BT-NG-020621-545-0287

Bramford to Twinstead Reinforcement

**Document 8.9.5 (B): Temporary and Permanent Access Technical Note
– Suffolk County Council**

**Final Issue B
February 2024**

Drawing title: **AB-AP5: Chuch Hill, north of Burstall
 Proposed Visibility Splay
 Concept Design
 Sheet 1 of 1**

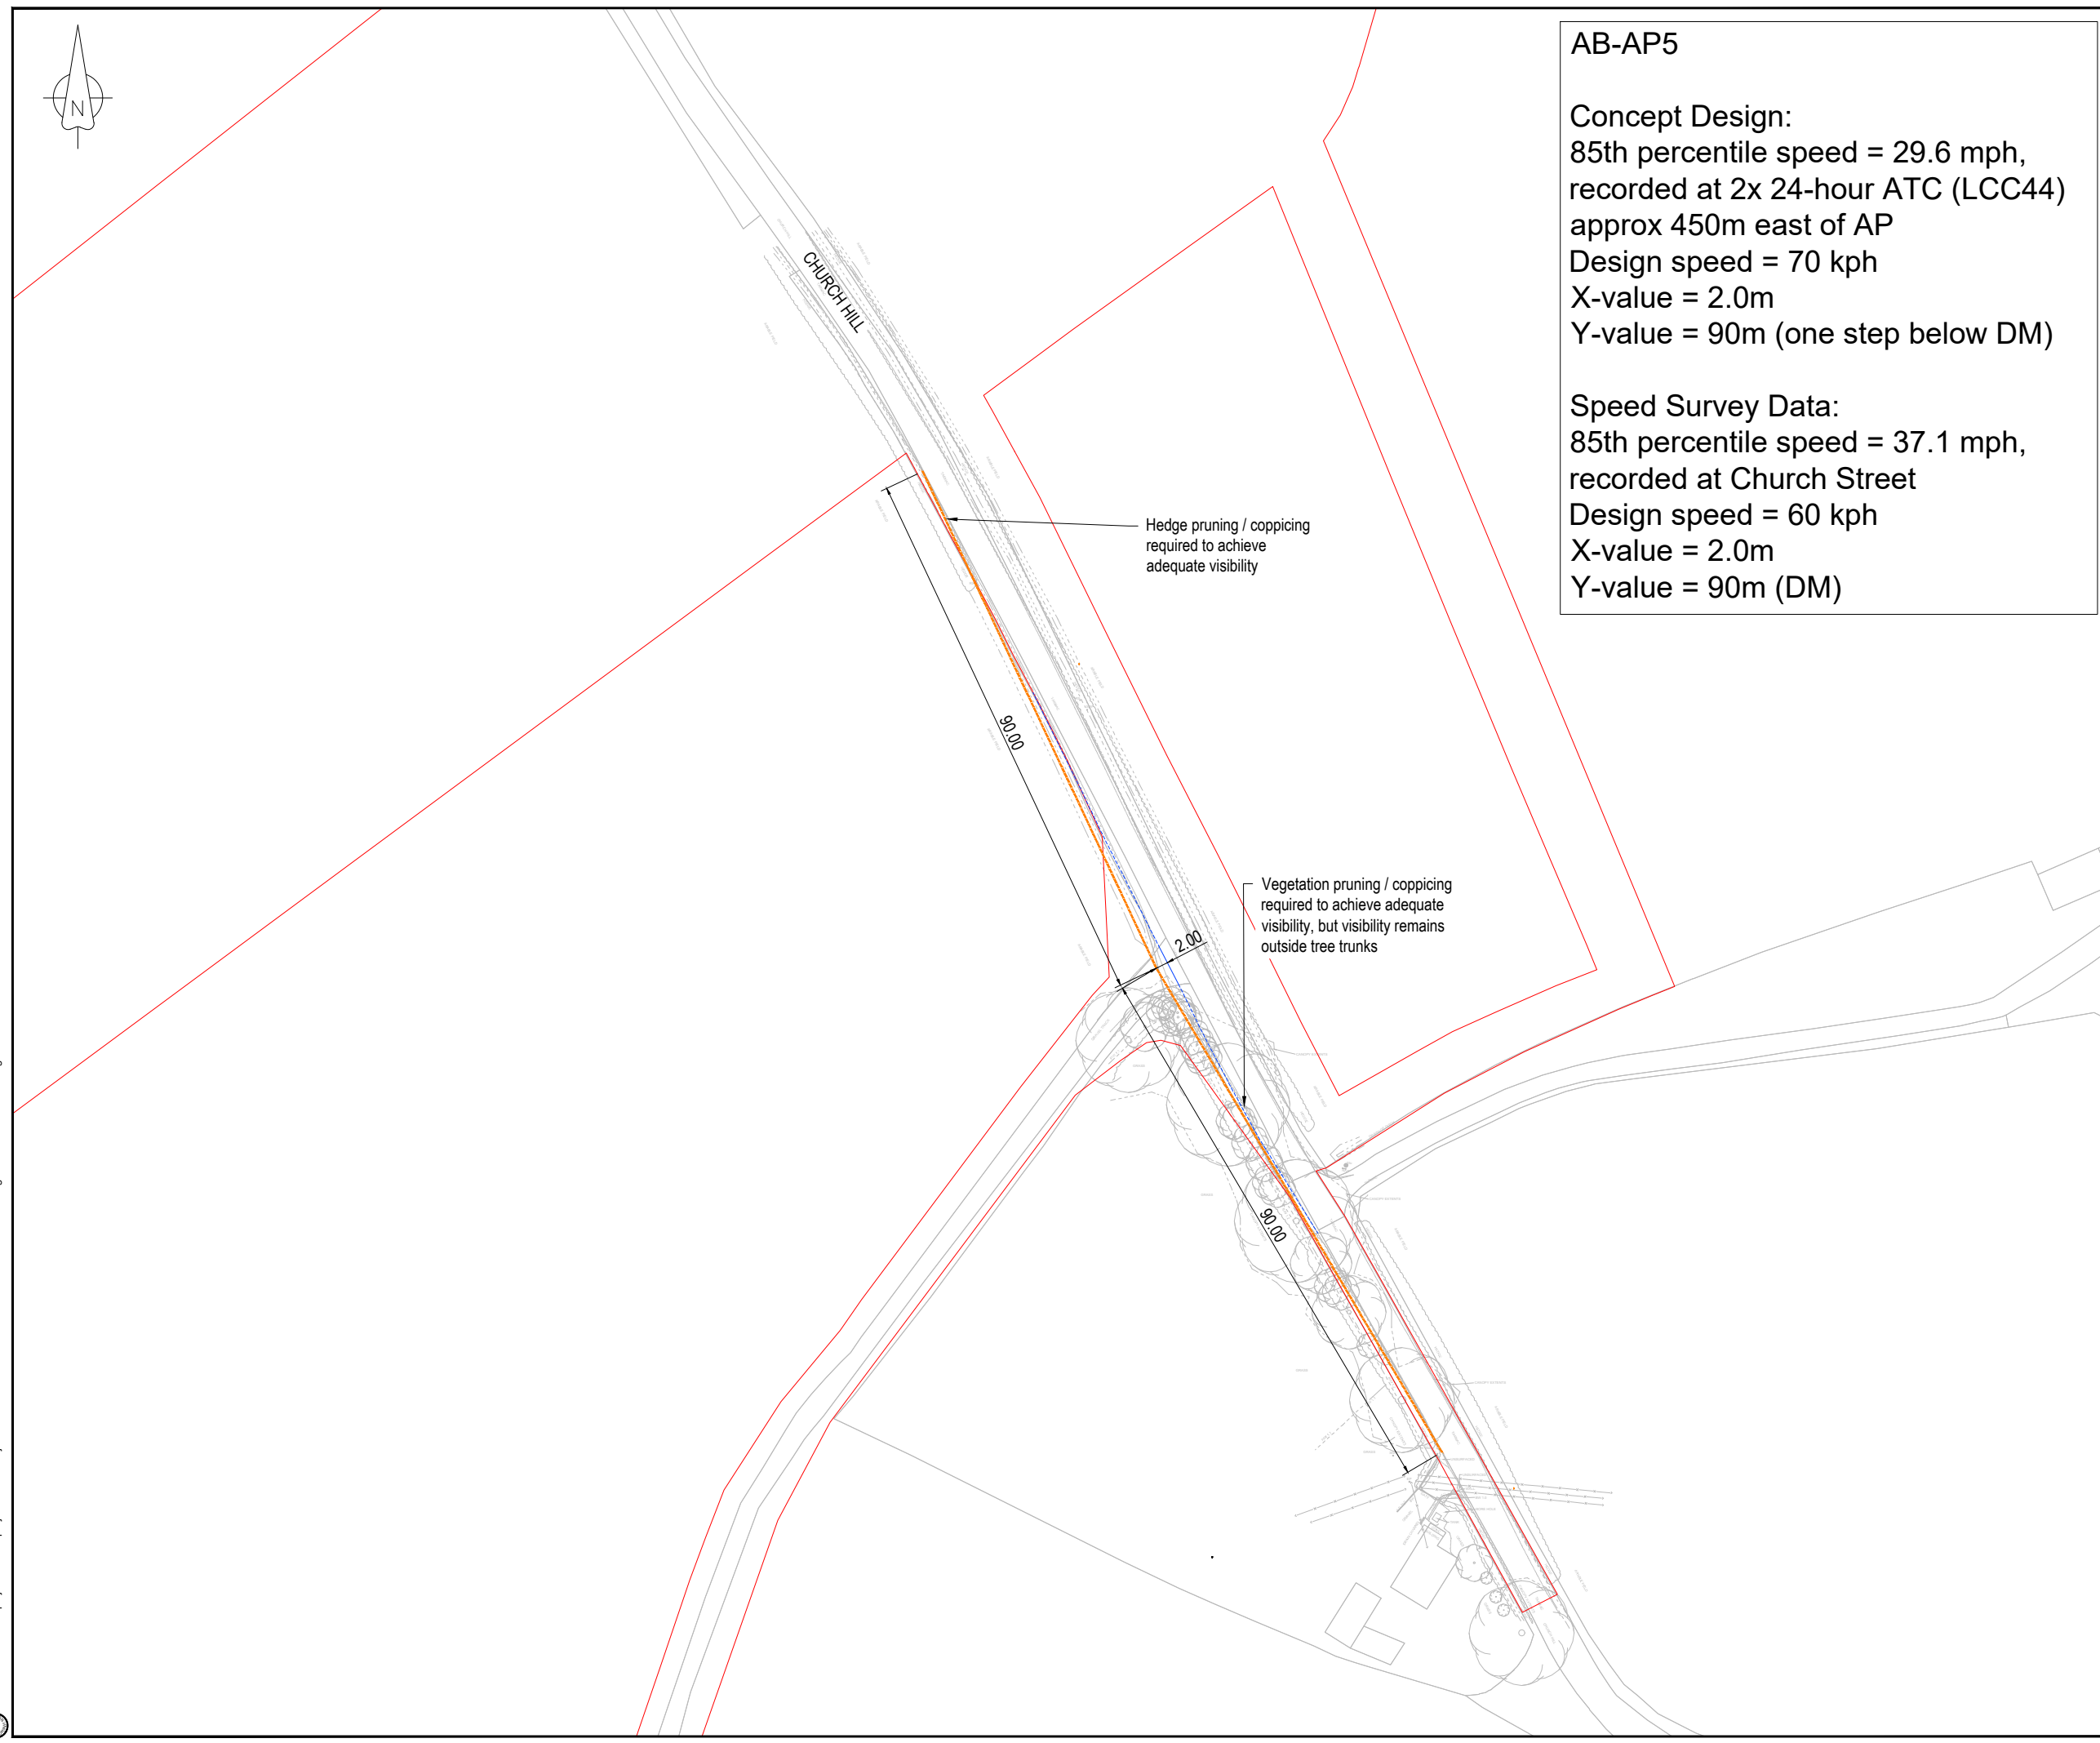
- 2.1.3 AB-AP5 is located north of a bend in the road, which is considered likely to reduce vehicle speeds at the access point and means that visibility to the south of the access point is limited primarily by the curvature in the road rather than by vegetation. The Applicant has drawn a visibility splay based on nearby traffic survey data, indicating that 70kph is the expected upper limit of the 85th percentile design speed, yielding a y-value, or distance along the major route of 90m (one step below the desirable minimum stopping sight distance). The Applicant has also considered the National Highways Design Manual for Roads and Bridges (DMRB) CD 123 – Geometric design of at-grade priority and signal-controlled junctions cl. 3.8, and proposes a x-distance of 2m which is appropriate for direct accesses. The x-distance is the distance away from the carriageway edge where the viewpoint of a driver of an emerging vehicle is positioned.

- 2.1.4 The Applicant has carried out a topographic survey in this location, which has determined that Church Hill widens in the vicinity of the existing private access. However, by maintaining the existing carriageway width of approximately 4.8m south and north of the junction by way of an edge-marking solution, the driver's eye position can be brought further down the access track towards Church Hill itself. This will essentially formalise the existing situation, where the carriageway extends towards the access track but the delineation point between Church Hill and the access track is the extension line of the edge of carriageway either side of the access.

- 2.1.5 The visibility splay shown in Appendix A requires the coppicing and pruning of vegetation within the functional highway to achieve the dimensions set out above, but the topographic survey has shown that the visibility splay does not interact with any surveyed tree trunks. Speed surveys are being carried out in January 2024 to confirm that the 70kph 85th percentile assumption is appropriate. Assuming that the speed surveys confirm assumptions to date, the visibility splays shown in Appendix A are considered appropriate. If the speed surveys show greater speeds than expected, the visibility splay shown would be revisited to determine whether a greater splay would be required or an alternative mechanism introduced to deliver an appropriate access.

- 2.1.8 A speed survey was commissioned in January 2024 at this location to confirm the 85th percentile design speed assumption was appropriate. The speed survey was carried out at this location because the data collected previously was not sufficiently close to the access and as a result of concerns raised about this access in particular during Examination of the application. Speed survey data obtained for the project prior to submission of the application is provided in document 8.9.2 Transport Assessment Traffic Survey Data [REP7-024]. The survey was undertaken at Church Hill, in the vicinity of the access point, for a seven-day 24-hour data collection starting 10 January 2024. Table 2.1 shows the outcome of the speed survey.

- 2.1.9 The design at application was based on a design speed of 70kph based on the 85th - percentile design speed from the previous traffic survey, and a 90m stopping sight distance, which is one step below the desirable minimum. The recent speed survey revealed that the design speed based on the 85th percentile is 60kph, which is lower than the design speed assumed for the sketch in Appendix A. For a design speed of 60kph, 90m is considered the desirable minimum stopping sight distance. Therefore, the survey confirmed that the approach taken in Appendix A is appropriate and no modifications are necessary to the visibility splay in the concept design.
- 2.1.10 The design developed shows that AB-AP5 is an appropriate access and safety requirements can be achieved at this location.

Concept Design:
 85th percentile speed = 29.6 mph,
 recorded at 2x 24-hour ATC (LCC44)
 approx 450m east of AP
 Design speed = 70 kph
 X-value = 2.0m
 Y-value = 90m (one step below DM)

Speed Survey Data:
 85th percentile speed = 37.1 mph,
 recorded at Church Street
 Design speed = 60 kph
 X-value = 2.0m
 Y-value = 90m (DM)

Drawing title
**D-DAP1: Rands Road, Layham
 Proposed Visibility Splay
 Concept Design
 Sheet 1 of 1**

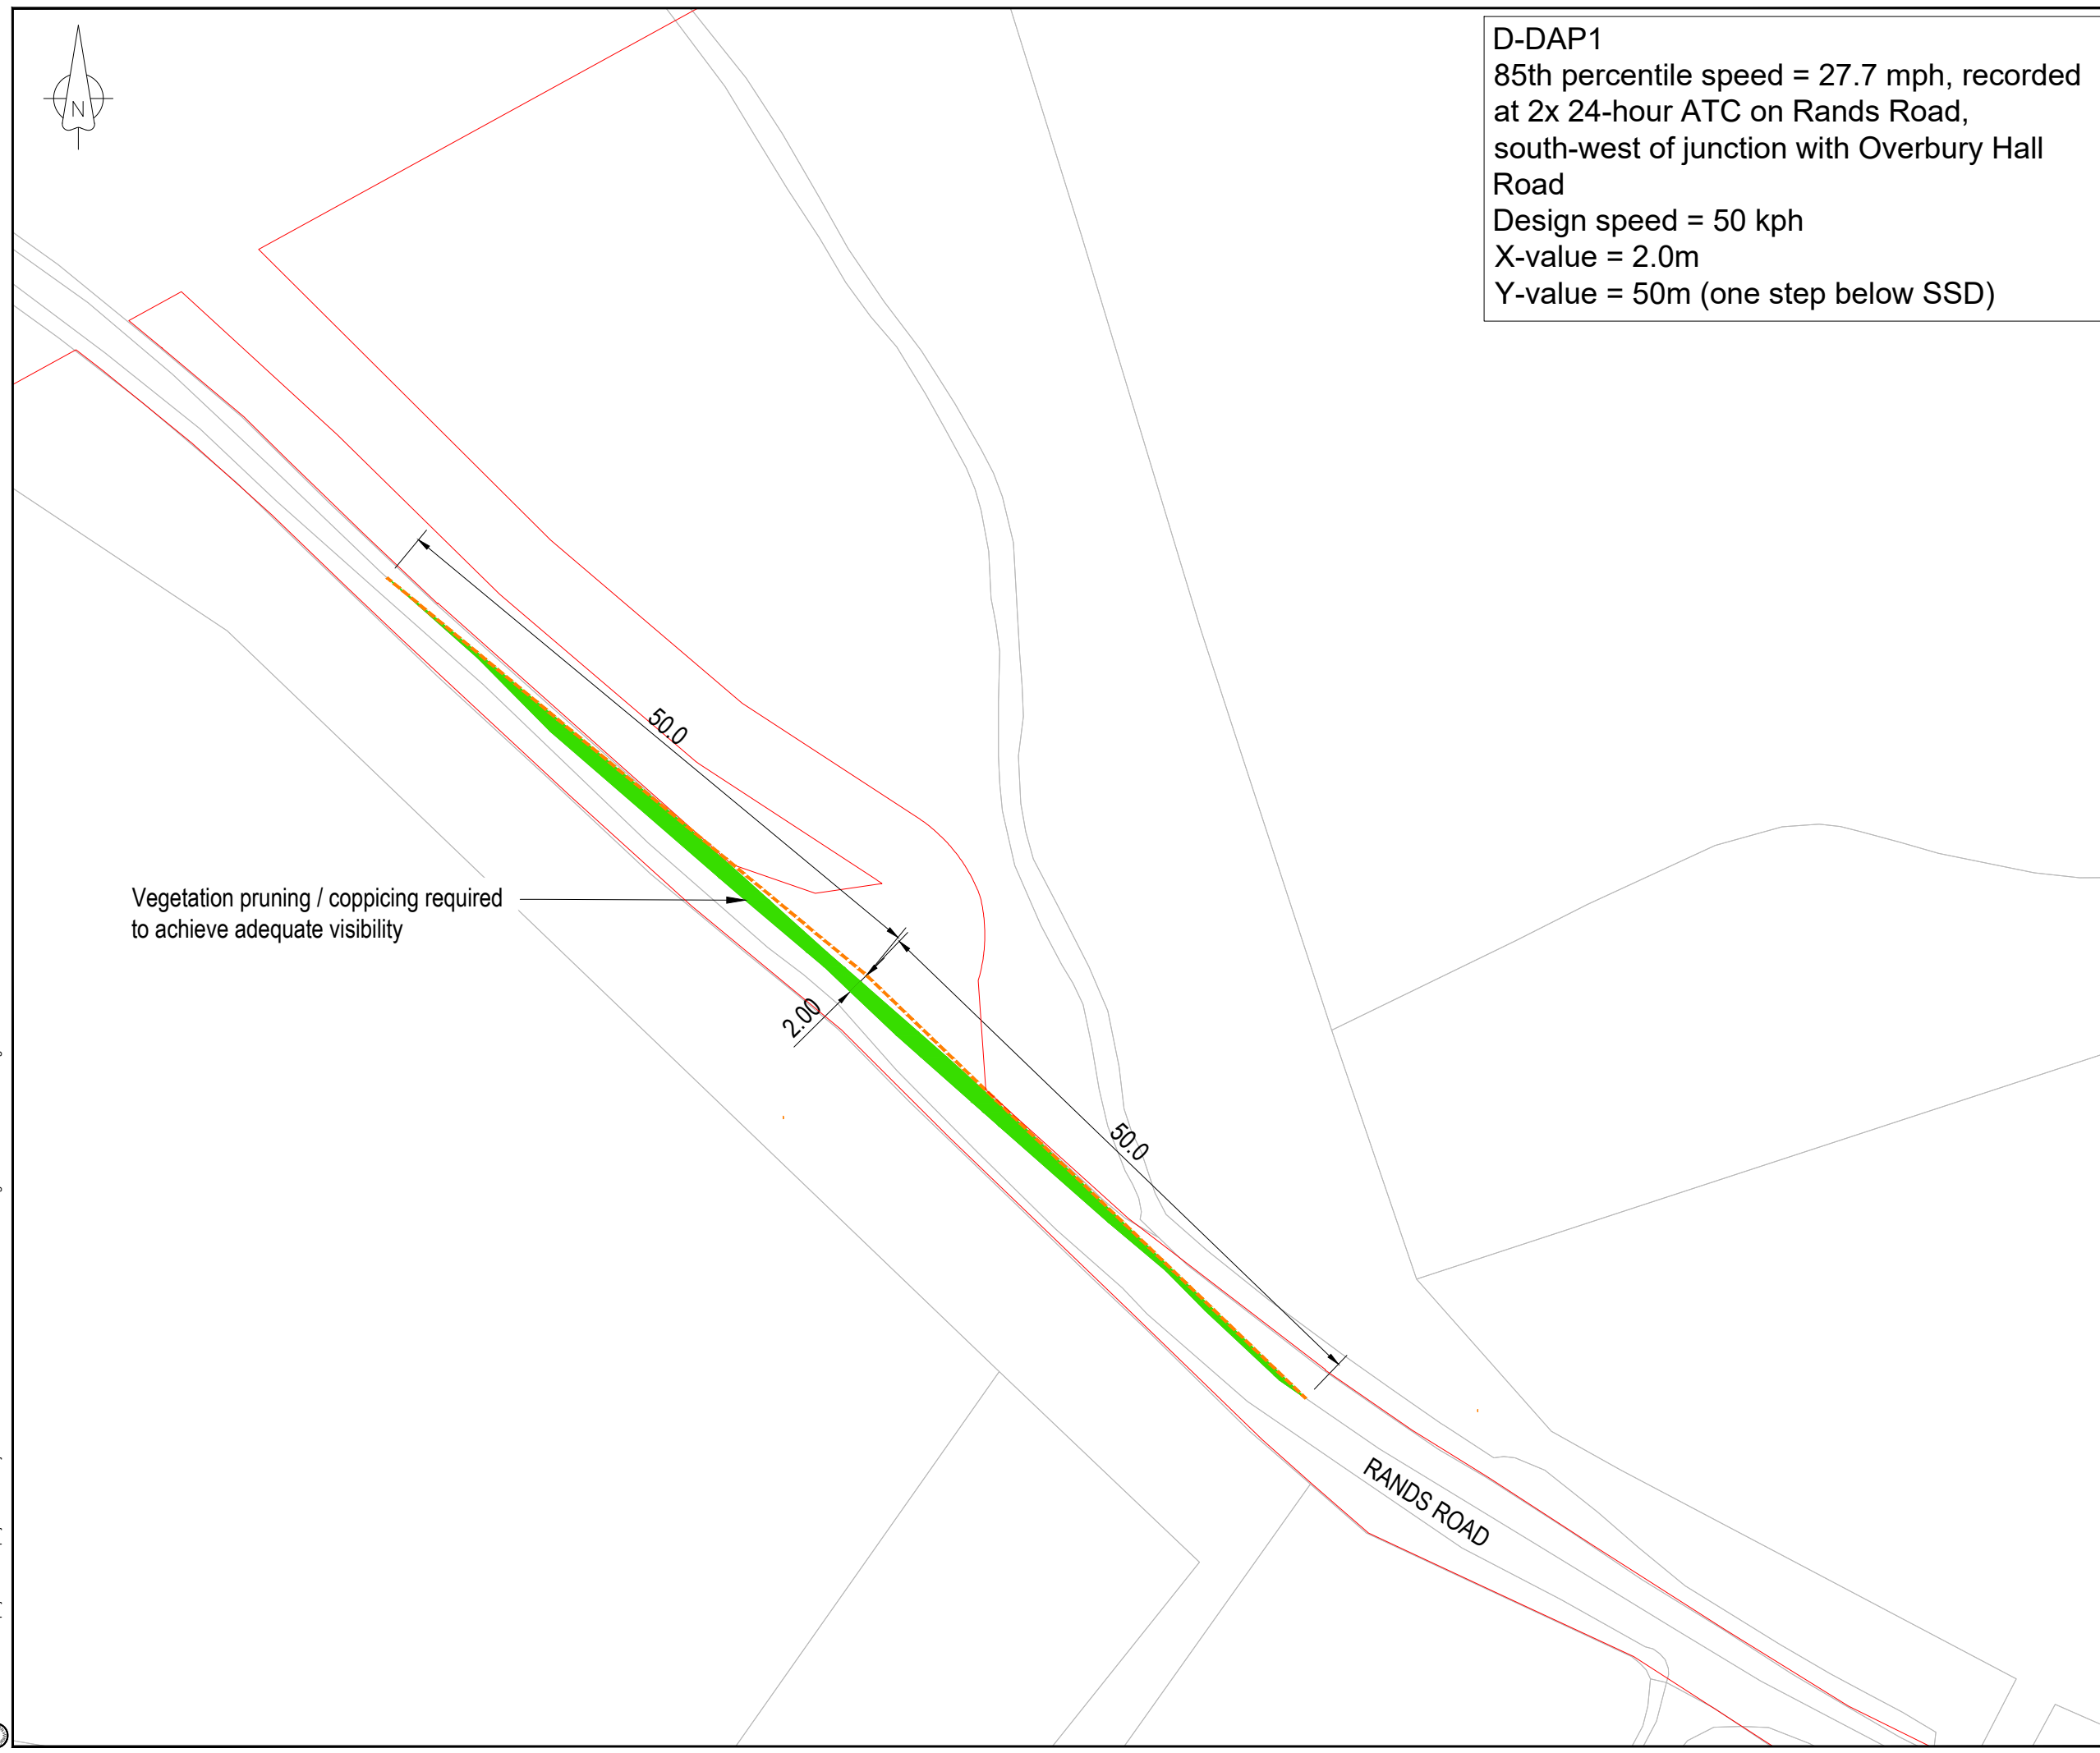
2.7.6 The combination of these aspects means that this access, which is only required for removal of the 132kV line, could have excessive impact on vegetation. Therefore, given the single track width and small scale nature of the work (primarily unloading plant/materials and loading removed apparatus), it may be appropriate to use a short-duration closure to create a more modest area of vegetation removal on a road-field boundary as an access to the adjacent farmland. This would be explored during the detailed design stage, but discussions confirmed that solutions were available. These noted that traffic management measures are likely to provide a more proportionate approach for this lightly-used access, to avoid excessive vegetation removal to provide the full visibility splay.

D-DAP1
 85th percentile speed = 27.7 mph, recorded
 at 2x 24-hour ATC on Rands Road,
 south-west of junction with Overbury Hall
 Road
 Design speed = 50 kph
 X-value = 2.0m
 Y-value = 50m (one step below SSD)
